M E M O R A N D U M

SUBJECT: Consideration of an Amendment to the Clean Water Plan for the Cuyahoga Valley Interceptor (CVI) Facilities Planning Area (FPA) to modify the FPA boundary and wastewater treatment prescription for the Cuyahoga Valley National Park's Environmental Education Center

RESOLUTION OF THE GENERAL POLICY BOARD OF THE NORTHEAST OHIO FOUR COUNTY REGIONAL PLANNING AND DEVELOPMENT ORGANIZATION (NEFCO) APPROVING AN AMENDMENT TO THE CLEAN WATER TO MODIFY THE FACILITIES PLANNING AREA BOUNDARY AND WASTEWATER PRESCRIPTION FOR THE CUYAHOGA VALLEY ENVIRONMENTAL EDUCATION CENTER IN SUMMIT COUNTY

Figure 2
Cuyahoga Valley Interceptor Facilities Planning Area
 208 Clean Water Plan Amendment
 Current FPA Boundary and Wastewater Treatment Prescriptions

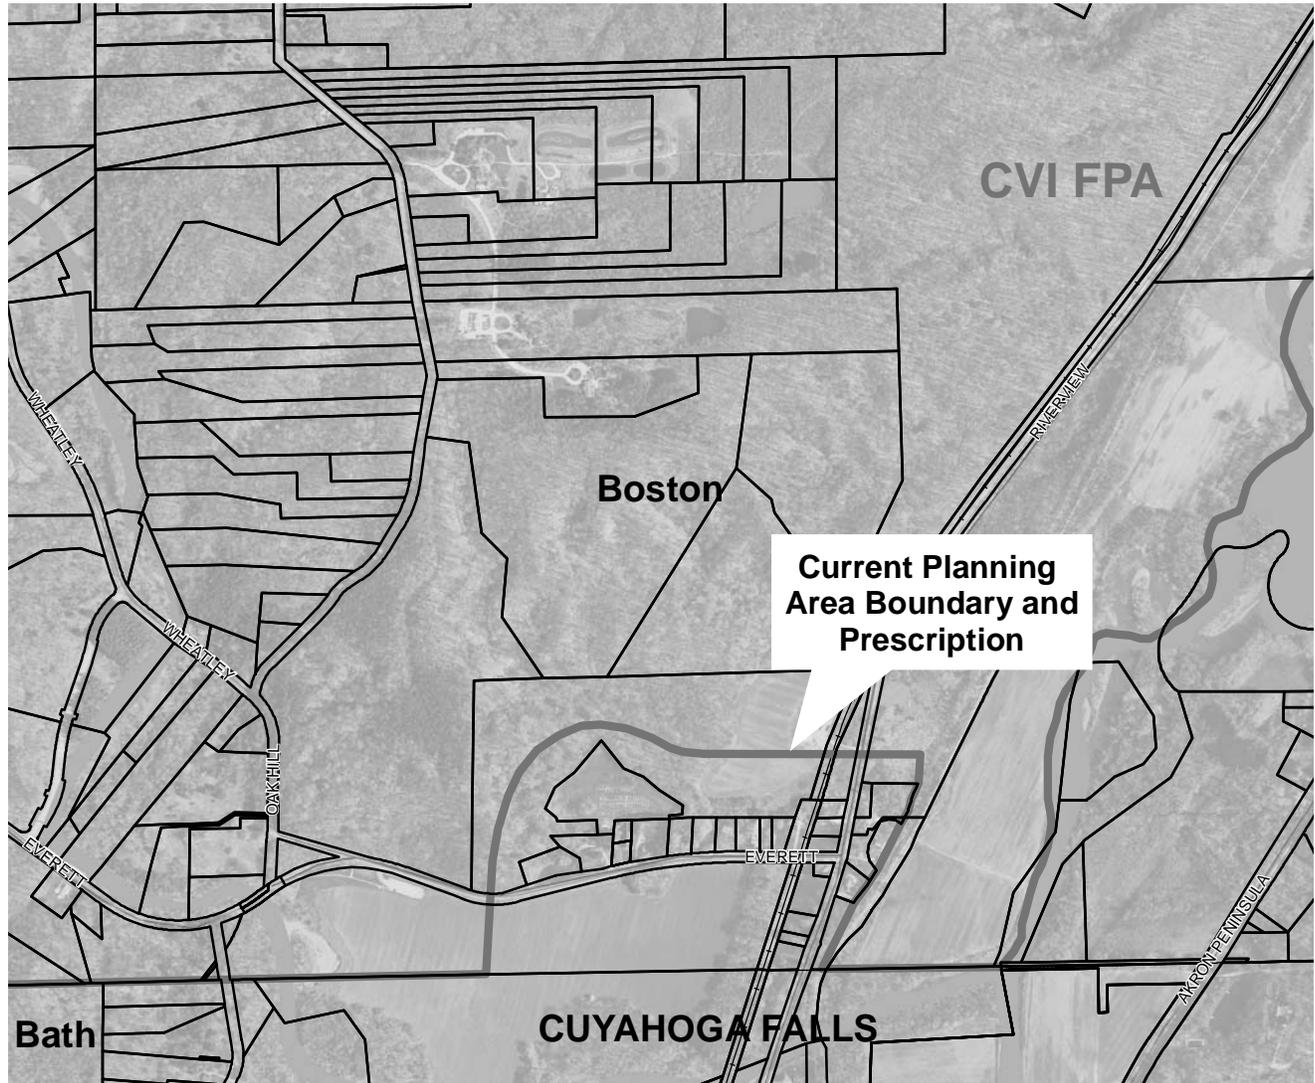
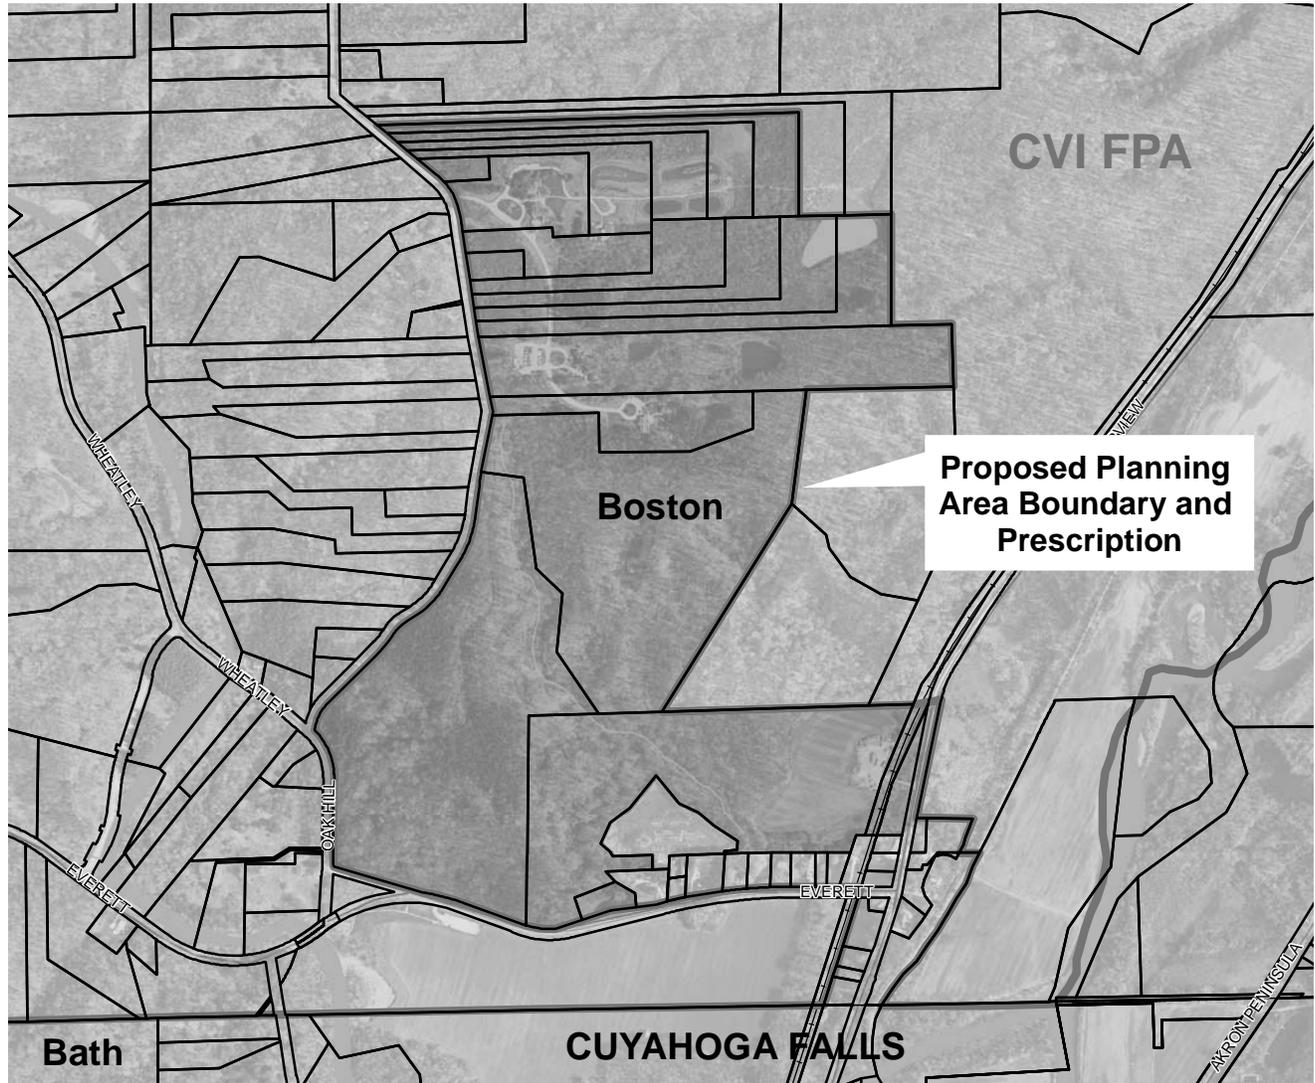
An overview of the amendment area is shown in Figure 1. Figure 2 shows the current FPA boundary for the area, and Figure 3 shows the proposed FPA boundary. The amendment would transfer the sixteen (16) CVNP parcels from the CVI FPA to an

The amendment will also adjust the previous 2009 FPA boundary amendment to better correspond with existing parcel boundaries. The 2009 amendment was completed prior to NEFCO's emphasis on following parcel lines where practical for 208 Plan map amendments. This adjustment to parcel boundaries would result in the non-CVNP parcel south of Everett Road to be shown entirely within the CVI FPA, and the entire CVNP-parcel east of Riverview Road and next to the Ohio & Erie Canal entirely within the undeclared planning area. These two parcels are currently split between the CVI FPA and the undeclared area as a result of the 2009 amendment.

Figure 2 shows the current prescriptions for the sixteen CVNP parcels plus three CVNP-parcels from the 2009 amendment as "green" or "areas that will be served by a POTW (Publicly-Owned Treatment Works) or by on-site non-discharging systems." The proposed amendment would result in the prescription for these parcels being changed to the Akron FPA "orange" prescription which signifies "areas programmed for sewers in the next 20 Years" (Figure 3). The wastewater treatment prescription for the Church of the Valley parcels north of Everett Road will remain "green" or "areas that will be served by a POTW or by on-site non-discharging systems."

Figure 2
Springfield No. 91 and Canton-Nimishillen Basin
Facilities Planning Areas
 208 Clean Water Plan Amendment
 CAK Phase III Project Area
 Current FPA Boundary and Prescription

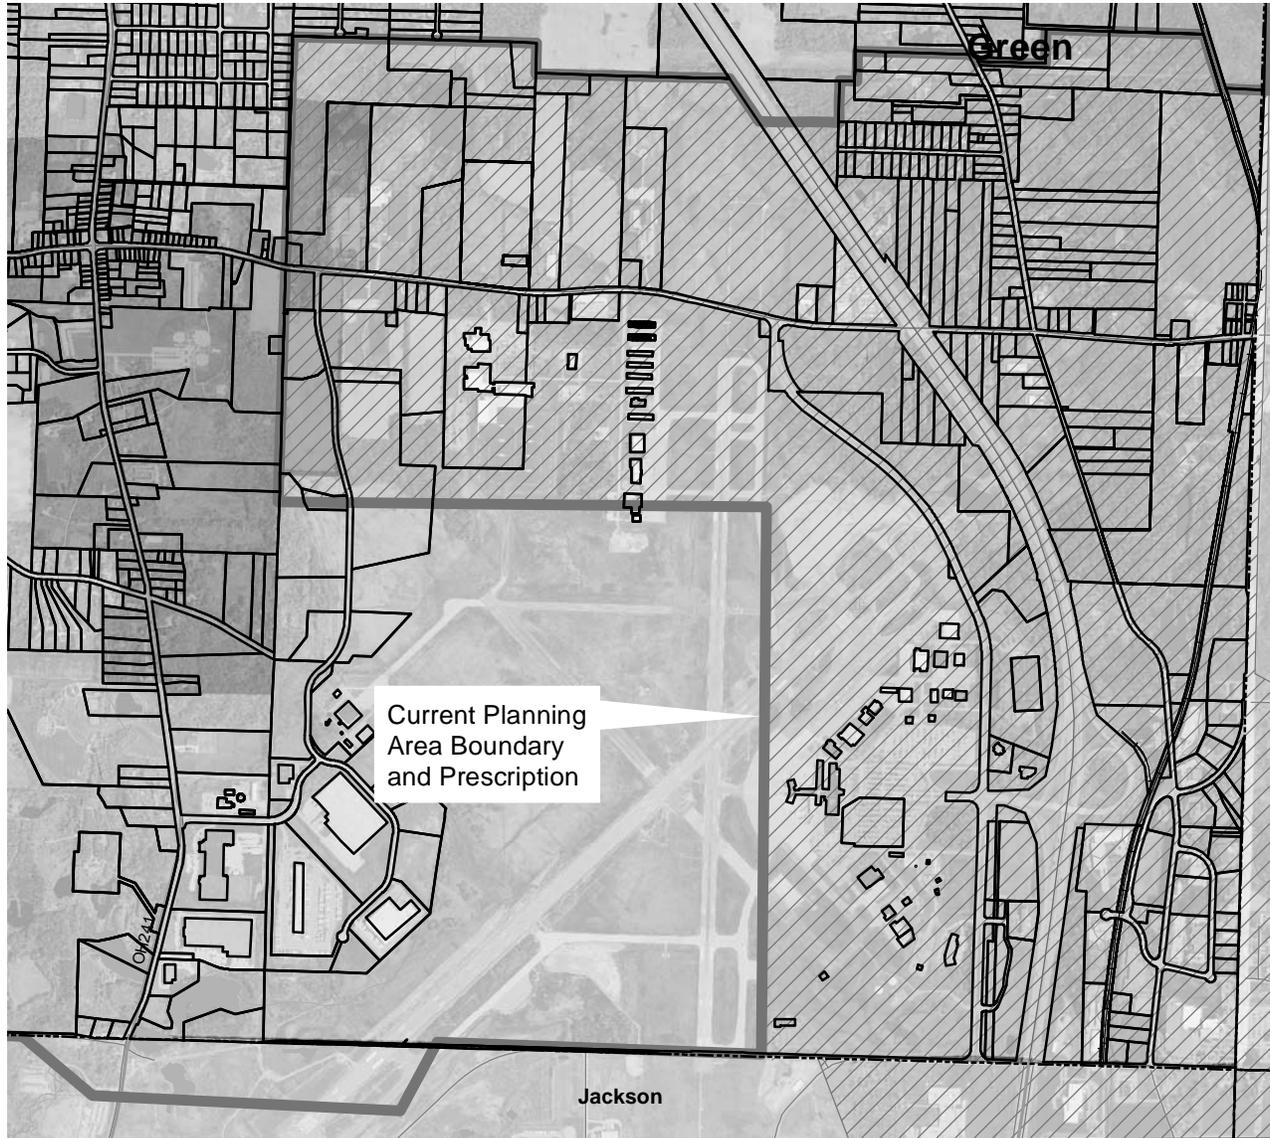
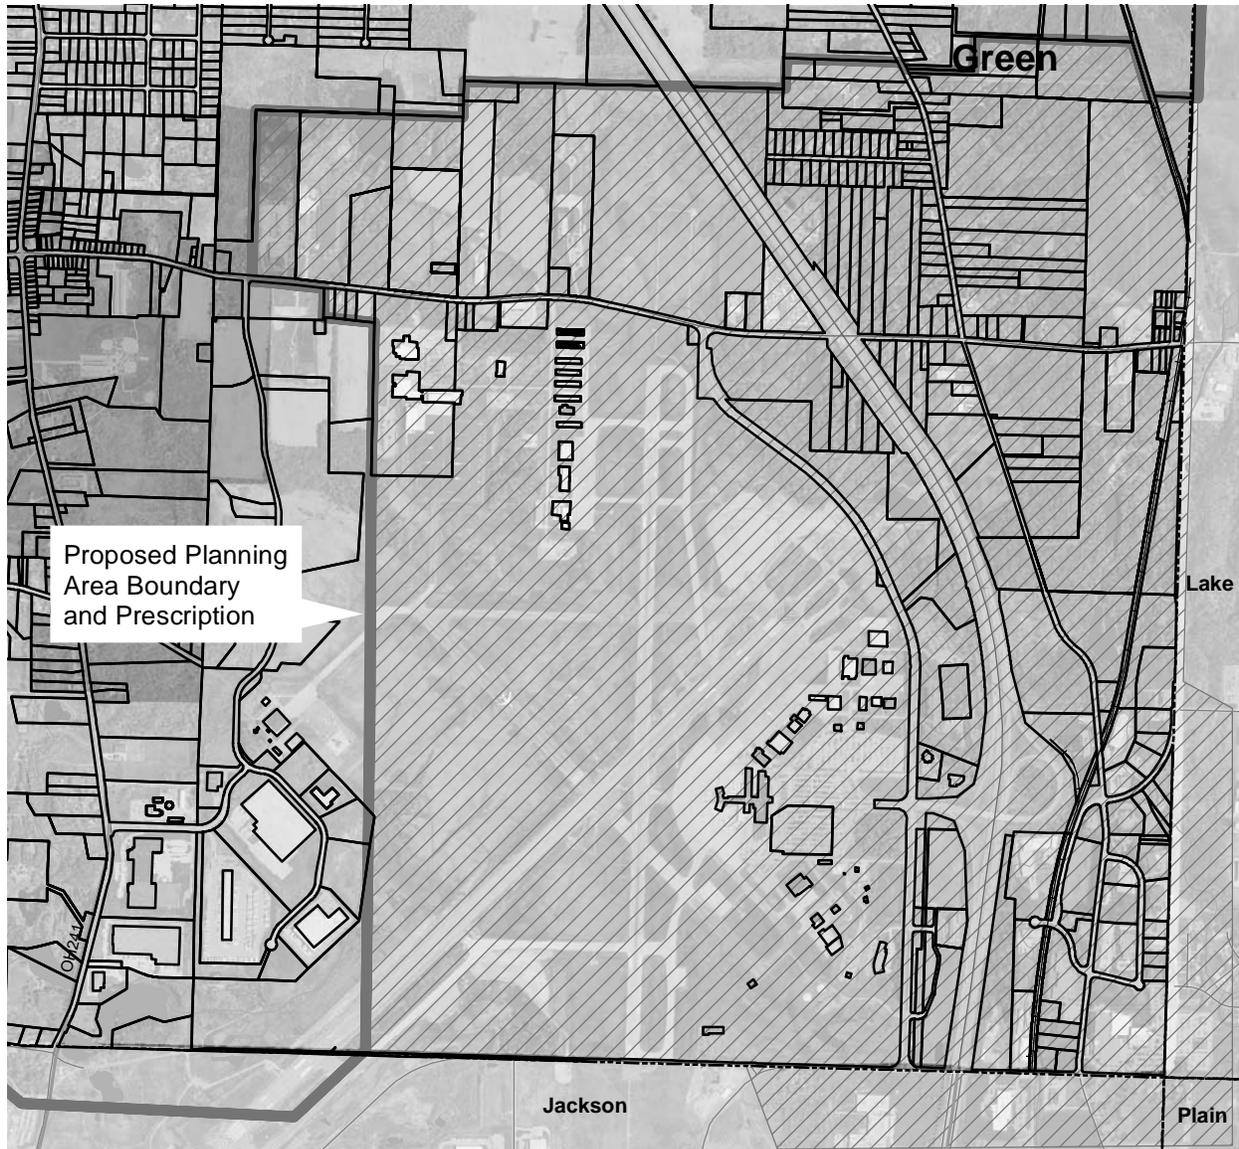
The current FPA boundary between the Springfield No. 91 and the Canton-Nimishillen Basin FPAs is shown in Figure 2. The proposed amendment would shift the boundary to the east to include all or part of eleven (11) parcels that are part of the CAK International Business Park Phase III development (Figure 3). This would allow the City of Green to extend sewers to the north from Phases I and II of the International Business Park to serve these parcels. Additionally, eight (8) parcels would be totally or partially shifted between the two FPAs to clean up the boundaries and put them more in alignment with the Stark-Summit Service Area. The wastewater from CAK Phase III will be treated at the County of Summit's Upper Tuscarawas WWTP.

The Stark County Metropolitan Sewer District supports your request to revise the boundary separating these Facility Planning Areas (FPA) and recommends approval of the new boundary as shown in Figure 3 CAK Phase III Project Area dated May 27, 2014.

Figure 3
Cuyahoga Valley Interceptor Facilities Planning Area
 208 Clean Water Plan Amendment
 Proposed Wastewater Treatment Prescription

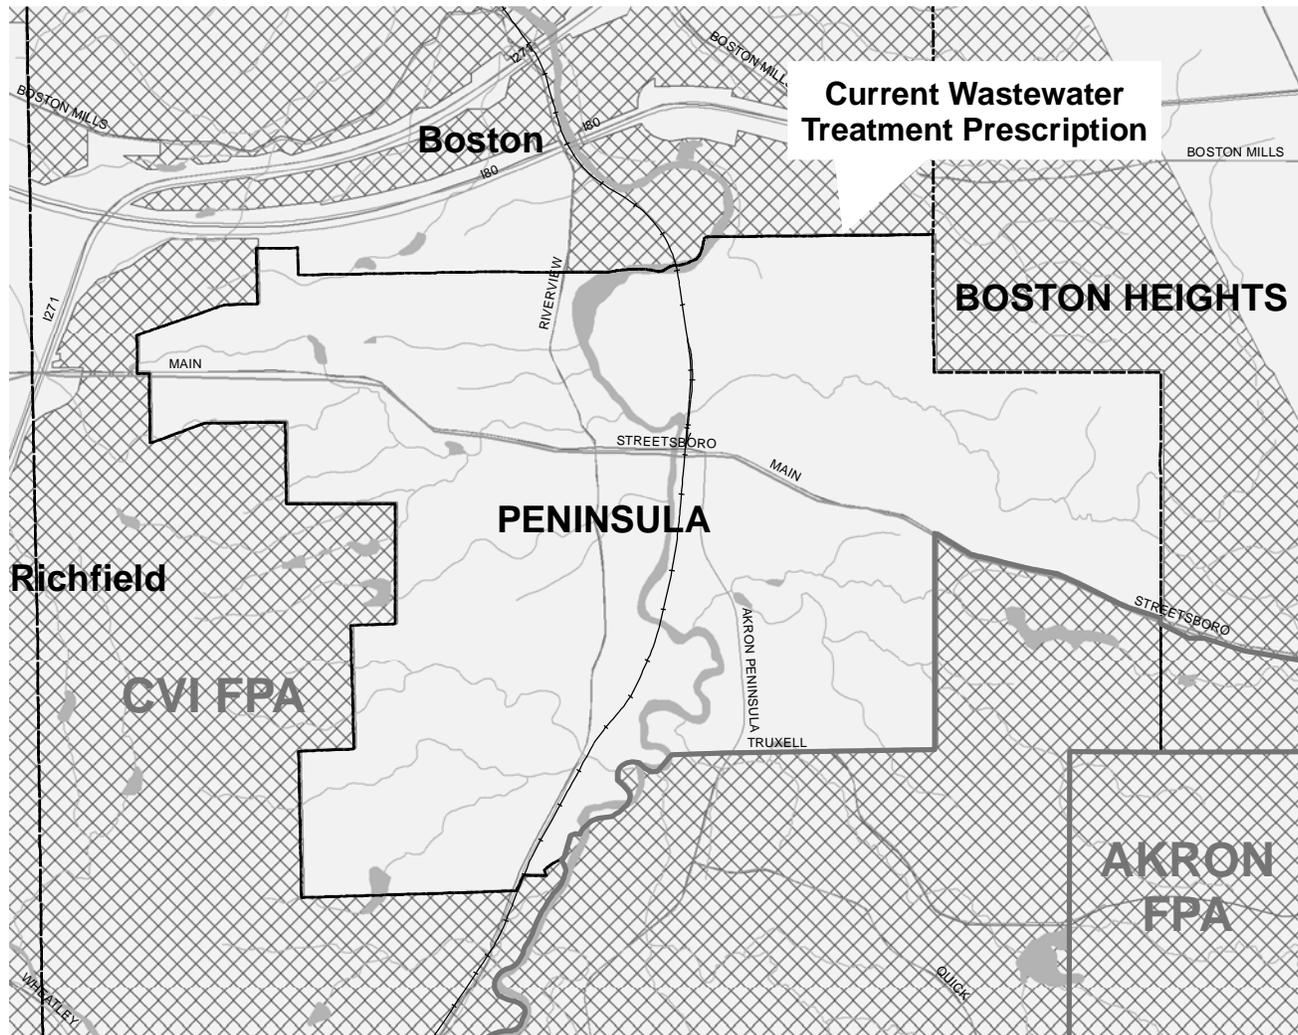
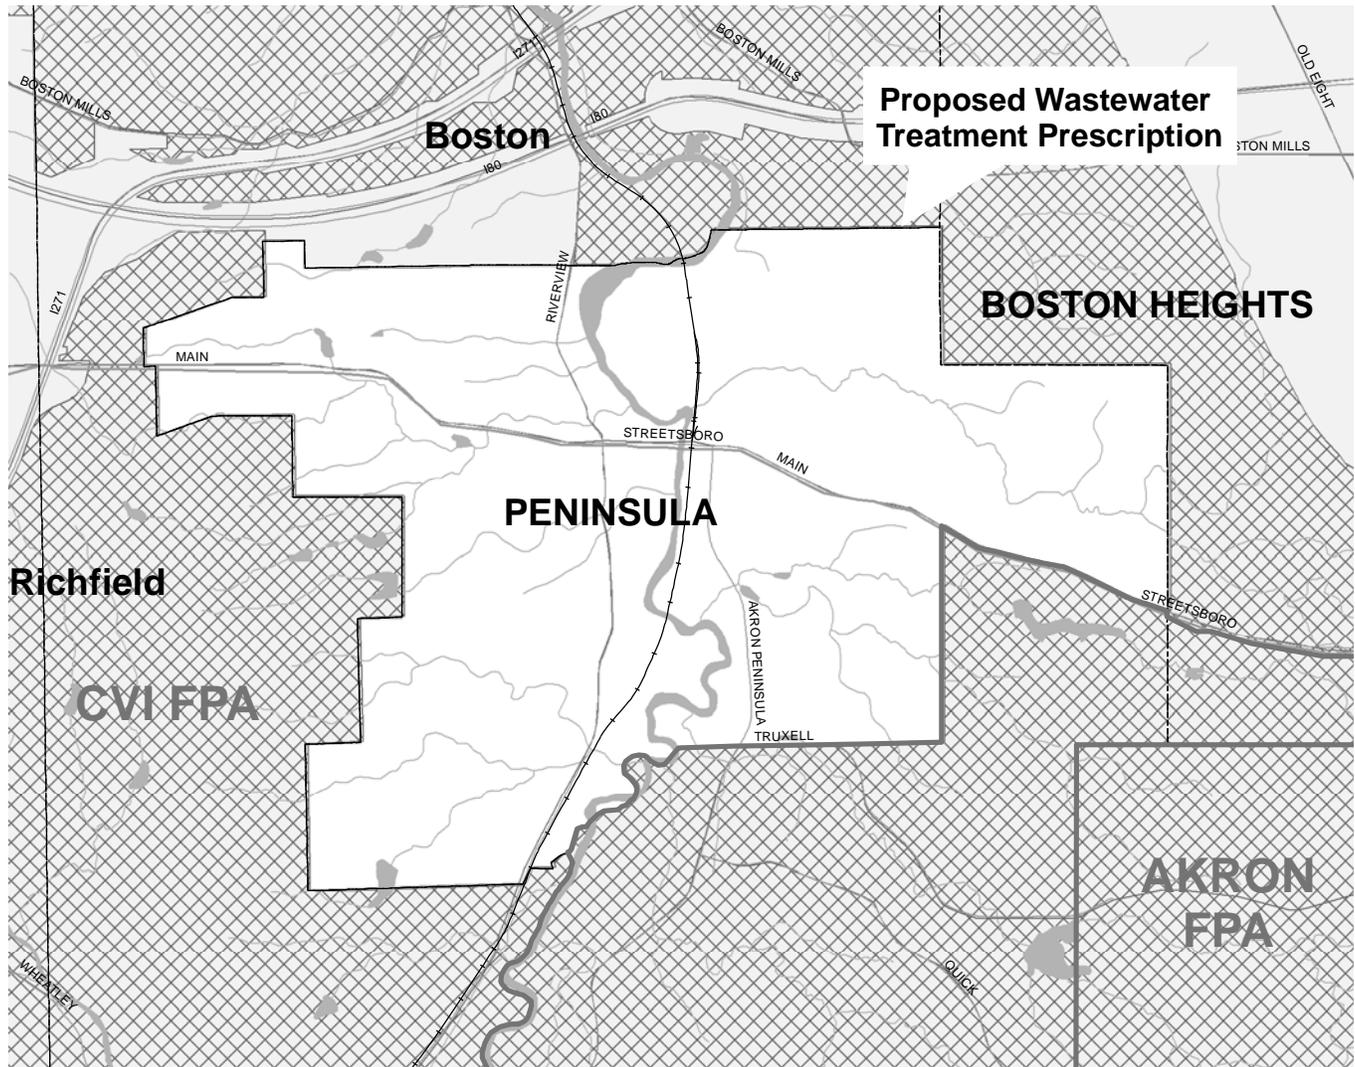
Since prescriptions were never developed for the Village, NEFCO is proposing to remove from the CVI FPA map the wastewater treatment prescription for the entire Village of Peninsula. The area will go from being shaded "light green" to being "white" on the map (Figure 3). The practical effect of this amendment would be that Ohio EPA could then issue NPDES and PTI permits for discharging wastewater treatment systems if that is determined to be the best wastewater treatment alternative. Issuing permits for discharging treatment systems by Ohio EPA is not an option in the current 208 Plan due to the discrepancy between the CVI FPA map and the 208 Plan text.
